Hexham rail roads submission SS1 - 4992

10th September 2012

We wish to oppose the Hexham rail project and put forward the following reasons for our objection.

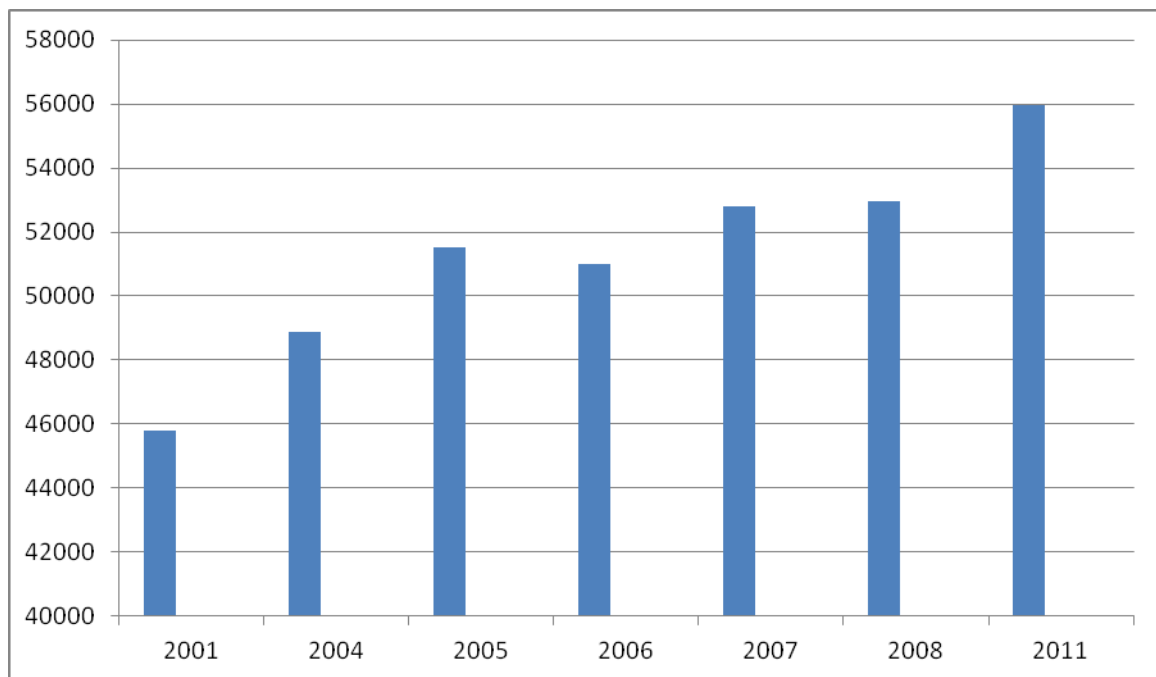
The existing traffic conditions and volumes also do not represent the current position.

Table 10.2d and e only show data up to 2008. That is four years ago.

The following table shows the position with the inclusion of the 2011 traffic volume of 55482 at count station 05.055.

Based on the construction traffic volumes 380 trips per day in table 10.3a the ADT would rise substantially to 56328.
